Re: BusConnects Bray to City Centre Core Bus Corridor Scheme
Bray to Dublin City Centre.

ABP case ref: 317742

BUSCONNECTS BRAY CORE BUS CORRIDOR SCHEME

Figure 2 Example of two stage pedestrian crossing at Waterloo Road

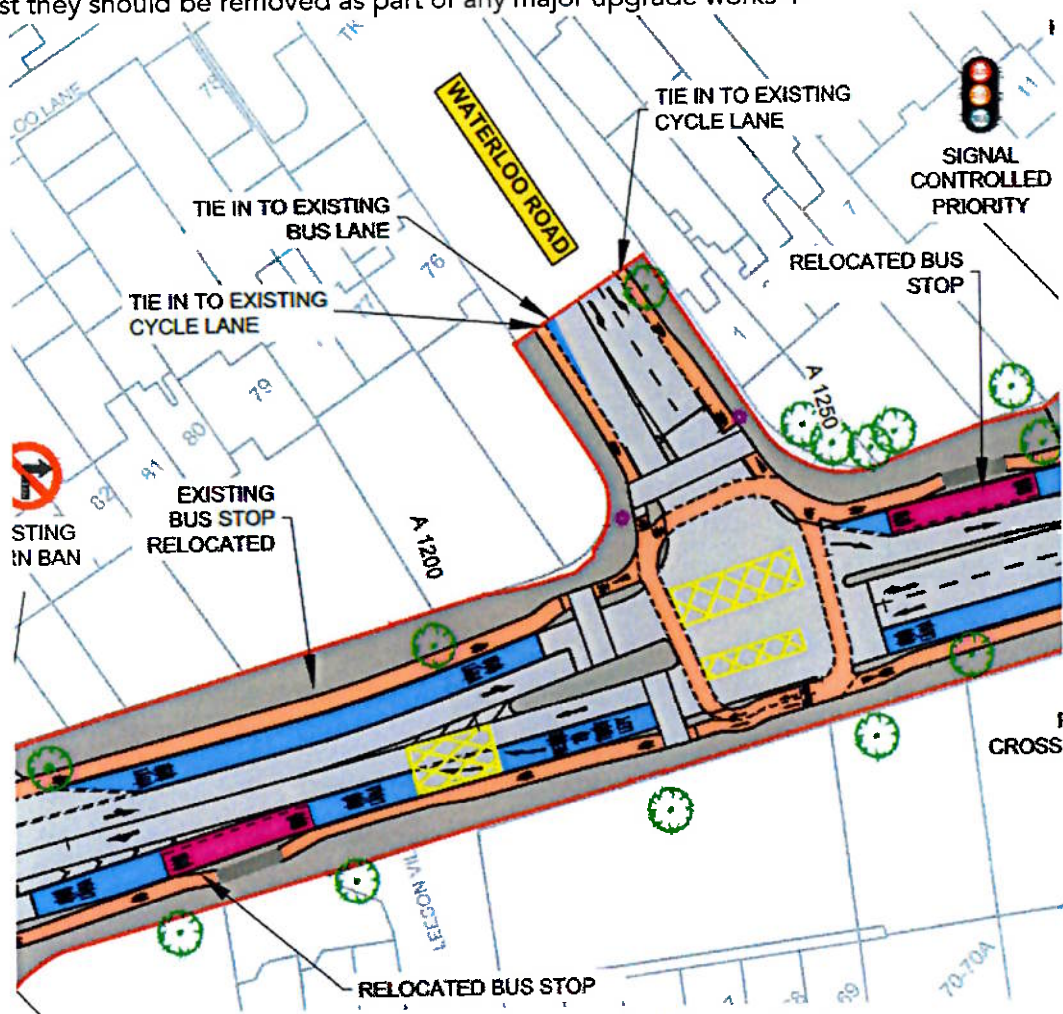
There are examples of two-stage pedestrian crossings proposed as part of this scheme. These crossings drastically increase the time required for pedestrians to navigate junctions and crossings. Section 4.4.3 Junction Design of the Design Manual for Urban Roads and Streets states that "designers should omit staggered crossings in favour of direct/single phase crossings" and Section 4.3.2 Pedestrian Crossings states that "designers should allow pedestrians to cross the street in a single, direct movement" and that "where staggered/staged crossings currently exist they should be removed as part of any major upgrade works".

The following two-stage pedestrian crossings are clearly inconsistent with the Design Manual for Urban Roads and Streets:

Figure 3 Bus stop with inadequate space to avoid conflict

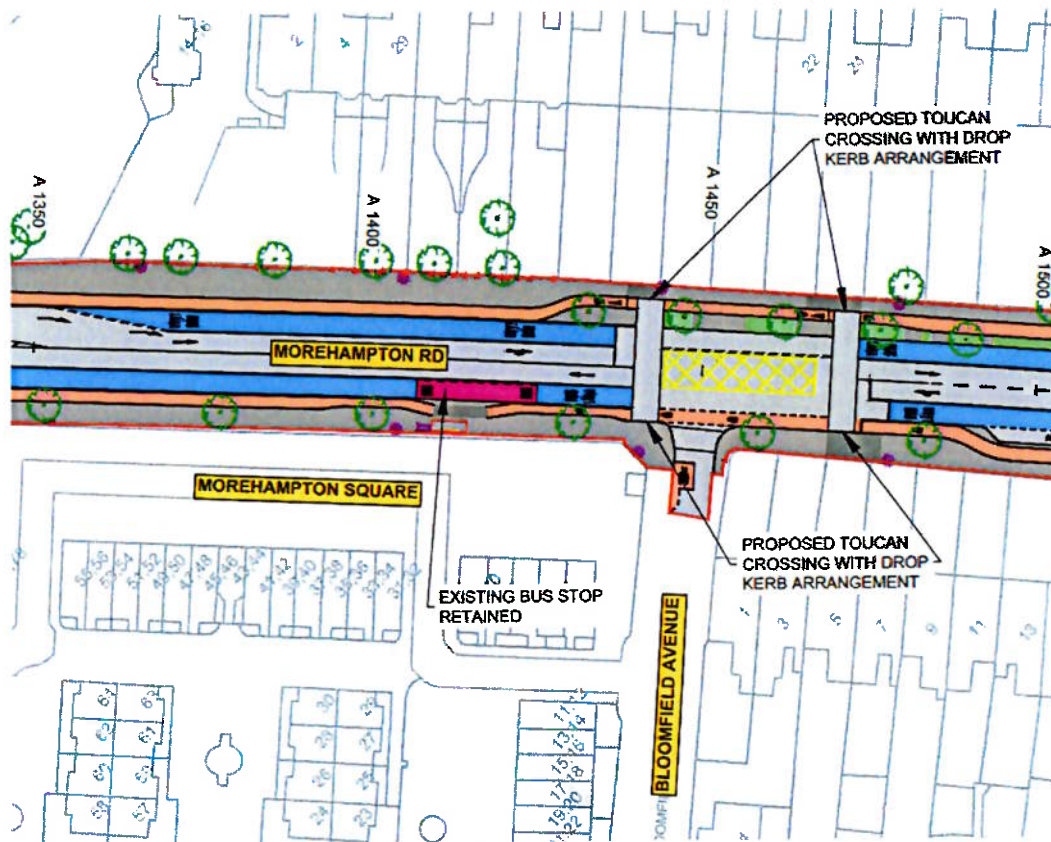
A major concern throughout the Proposed Scheme is the width of the bus stop islands that are proposed. Bus stop islands are crucial for the safety of cyclists and for encouraging all ages and abilities to use cycling infrastructure by removing conflicts between buses and bicycles. However, narrow islands place cyclists in conflict with boarding and alighting bus passengers.

Figure 5 Example of shared bicycle/pedestrian space at the connection the grand canal pathway

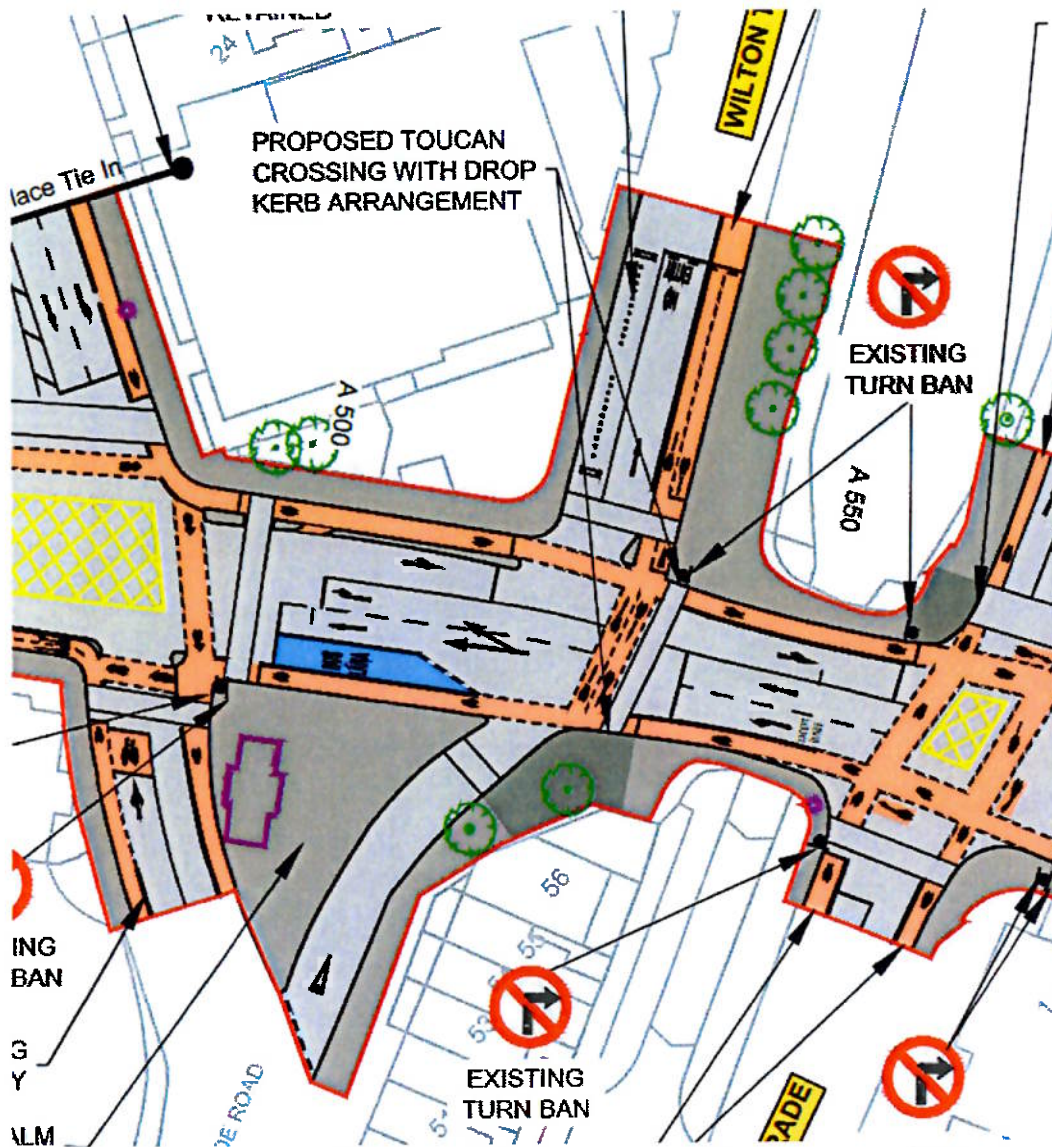
There are many junctions where the use of shared space pavement is provided where turning movements or yield areas are created for cyclists who are forced into the same spaces as pedestrians. This is significantly sub-standard given the wider scope of the Core Bus Corridor project and the potential influence it can have on the overall modal split within the Metropolitan area. This substandard design has the potential to seriously injure the vitality and usability of the public realm for the general public. Of particular concern is the conflict and danger presented by the use of shared space where it concerns those with disabilities, who may not be able to react or respond to the additional danger presented by shared space with cyclists adequately. Such additional risk can damage the reputation and general perception
